**APPENDIX 2.3  
PEDW EIA SCOPING DIRECTION**

## EIA Scoping Direction

# DNS CAS-03072-D7X6N7 – Alleston Solar Farm

13/03/2024

**Annex 1 – Predictive ALC Map<sup>8</sup> Grading of unsurveyed area.**

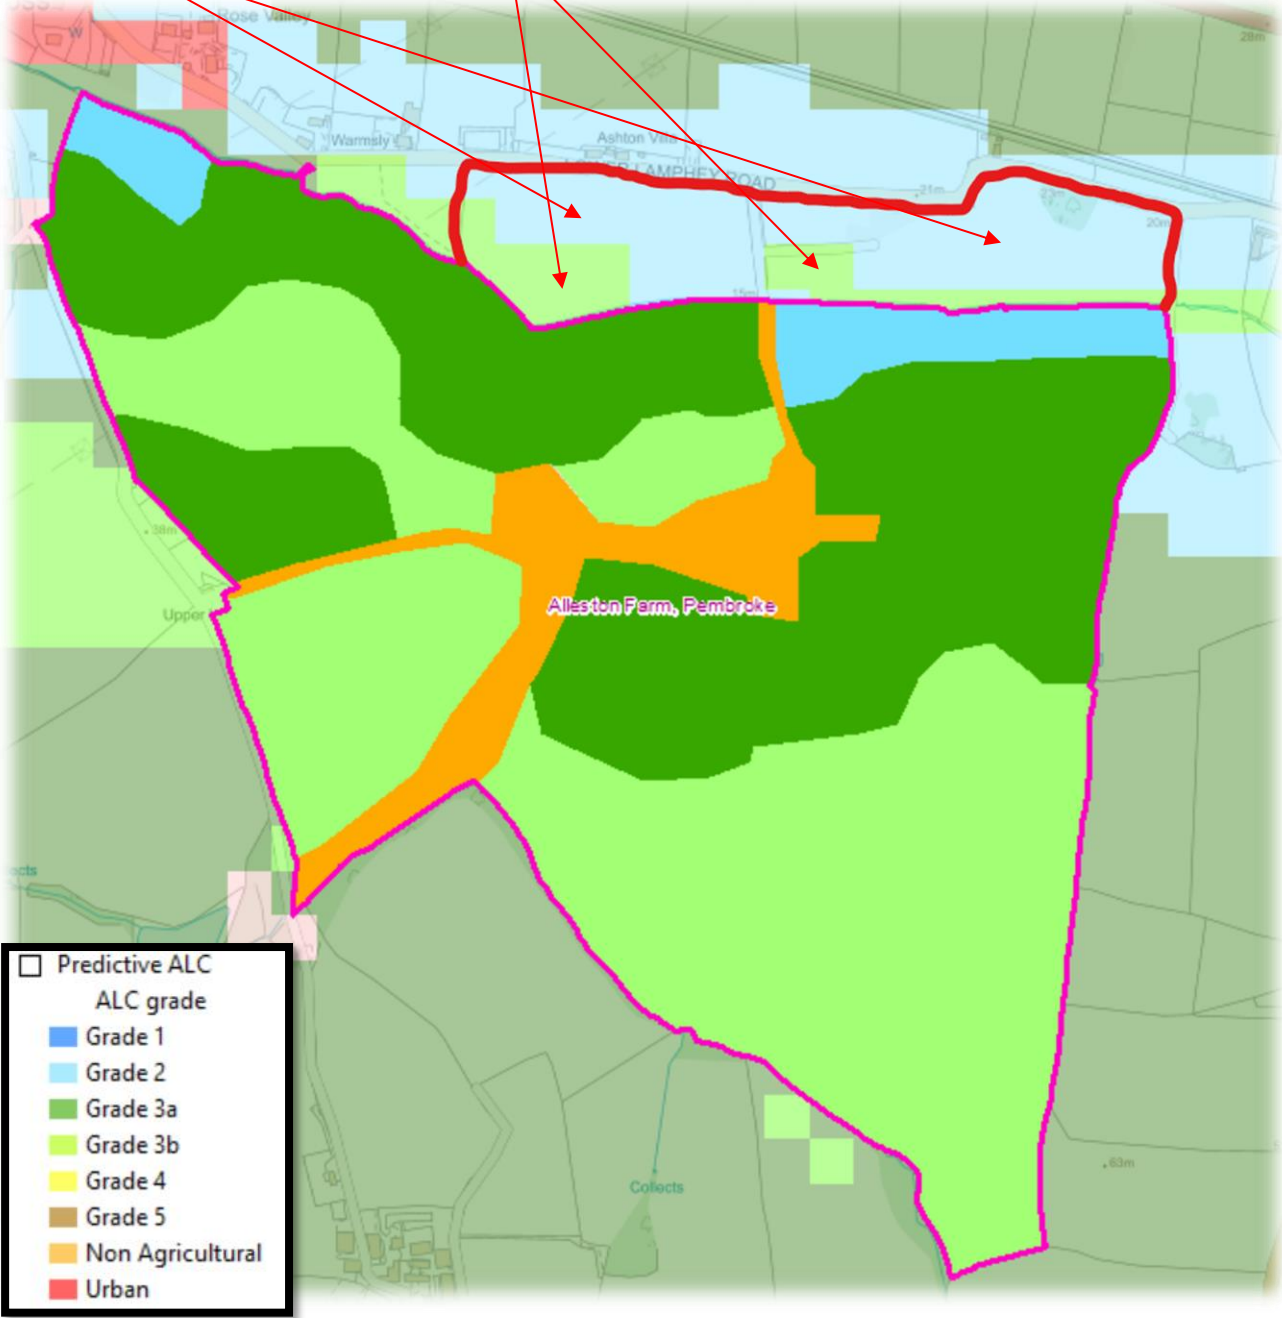
ID	Reference in Scoping Report	Issue	Comment
			<p>The 10 ha unsurveyed area in the north of the proposed site is noted as mainly Grade 2, with some Subgrade 3b on the Predicative ALC map. LQAS note that as per Departmental Guidance, where the Predicative ALC map identifies grades 1,2 or 3a a survey will be required to determine Grades present and in what proportion.</p> <p>LQAS highlight that the proposed application may contain more than 40 ha of BMV agricultural land.</p> <p>The applicant's attention is drawn to LQAS's comments in Appendix 1, regarding how the location and extent of soils on site can inform decisions on infrastructure siting, decommissioning and restoration of the site.</p>
ID.23	6.3	Best and Most Versatile (BMV) agricultural land policy	<p>The applicant's attention is drawn to LQAS's comments in Appendix 1, where it is highlighted that due to the significant area of BMV land within the site, the department expects the ES to include clear evidence of how PPW par. 3.58 and 3.59 have been addressed.</p> <p>LQAS also include in their comments the additional policy context that should be considered.</p>
